RFB 2122-01

**Rook Hall Tenant Improvement
General Contractor RFB**

Addendum No. 1

Sheet AD1.01

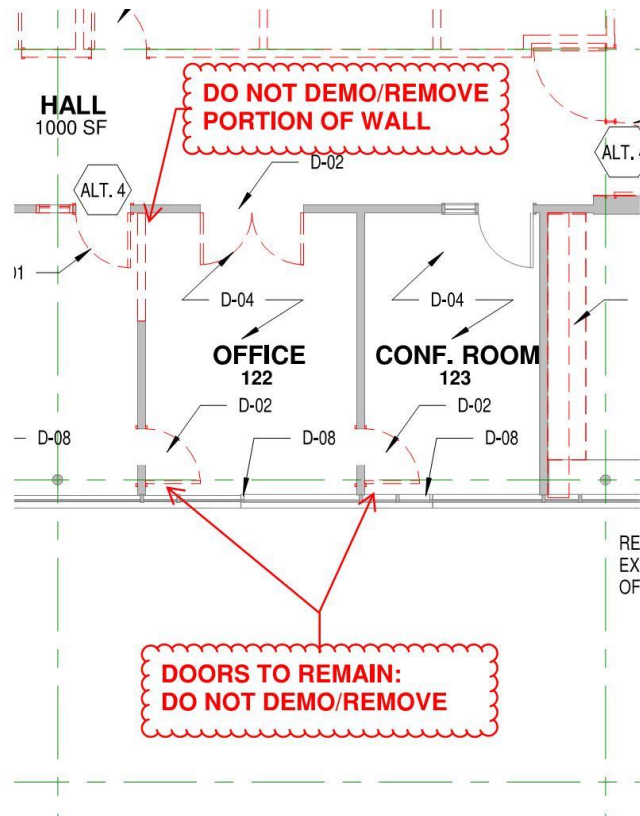
Two (2) doors to remain

Door from RECEPTION 120 to OFFICE 122 to remain (do not demo/remove)

Door from OFFICE 122 to CONF ROOM 123 to remain (do not demo/remove)

Do not demo portion of wall between RECEPTION 120 TO OFFICE 122

Sheet A1.01

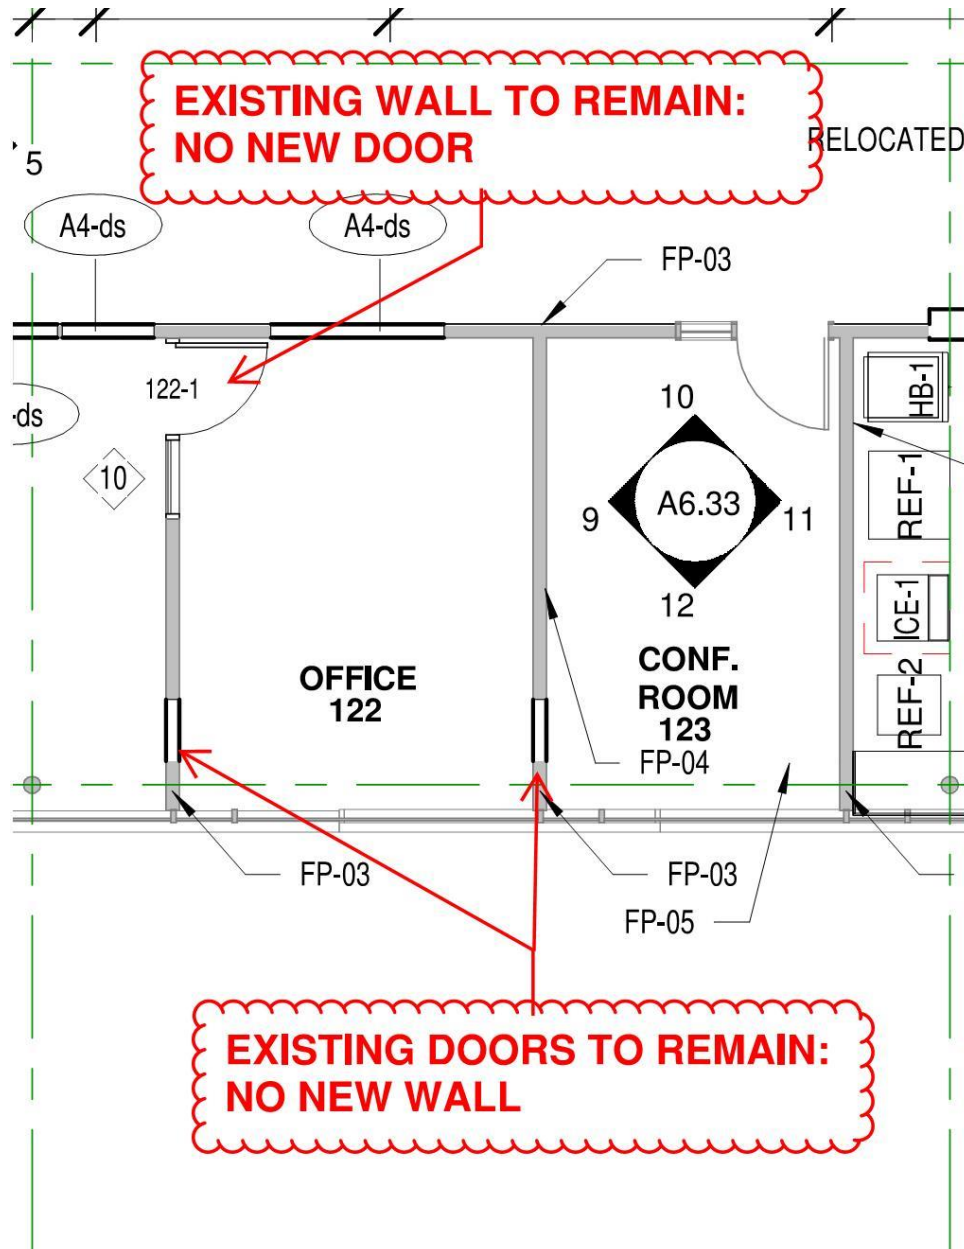
No new door (Door 122-1) from RECEPTION 120 to OFFICE 122

No new wall from RECEPTION 120 to OFFICE 122

No new wall from OFFICE 122 to CONF ROOM 123

Sheet A6.33 Detail 7

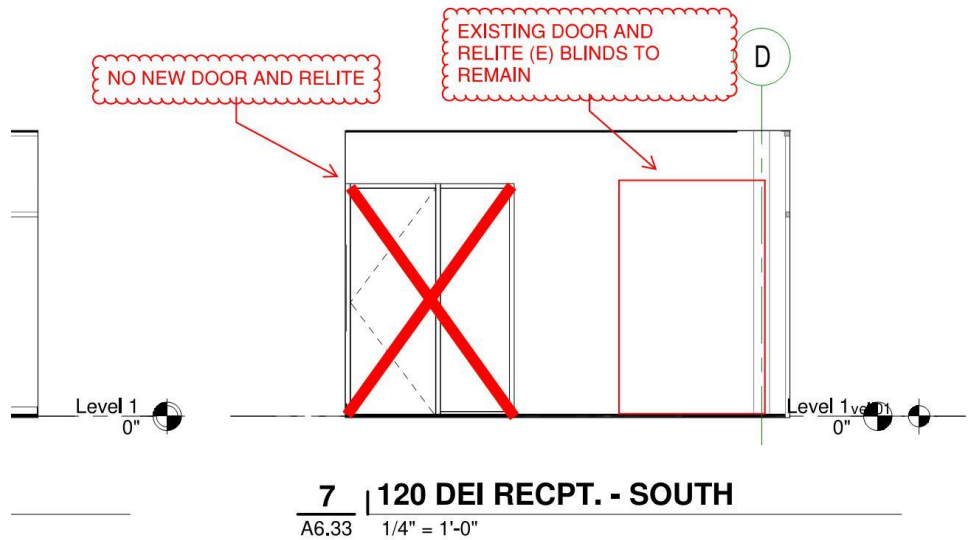
No new door and relite

Existing Door and Relite (E) Blinds to remain

Sheet P2.00

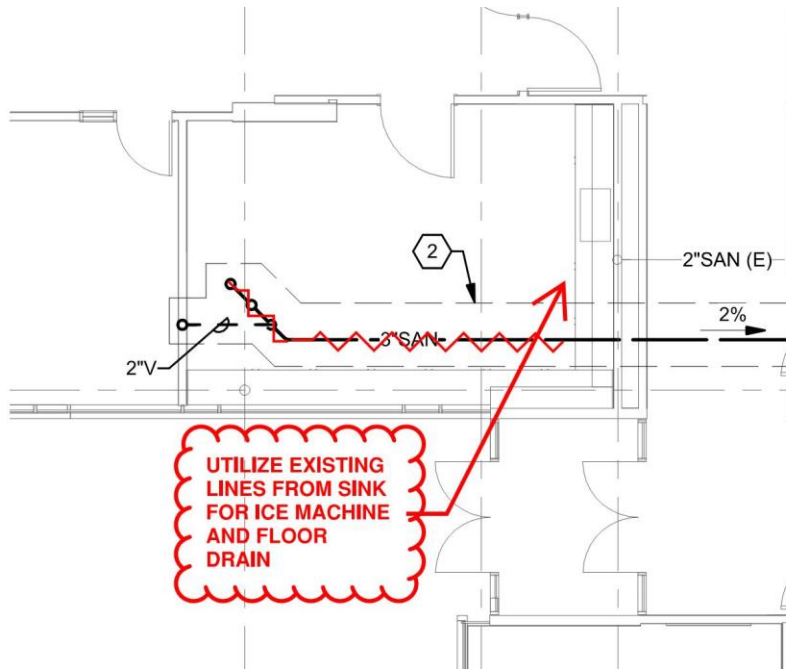
Reduce 3" Sanitary line and vent to new location of ice machine OR utilize existing lines from sink

Sheet P2.01

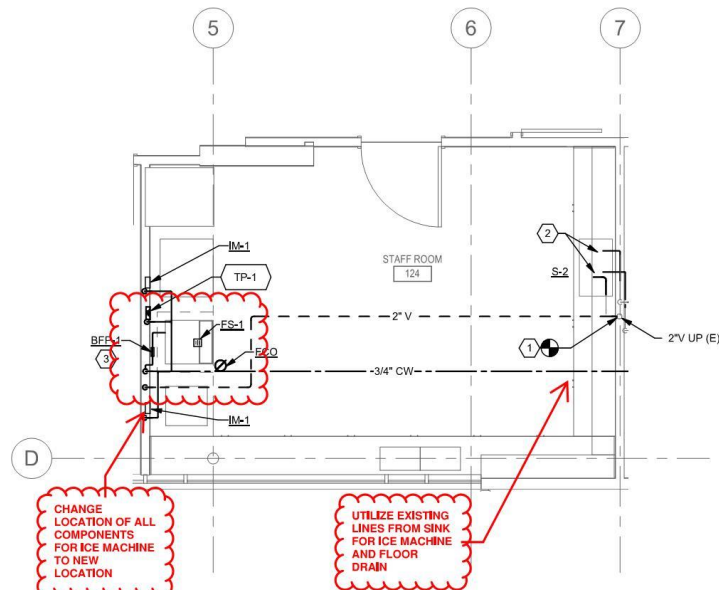
Move all services for ice machine to new location
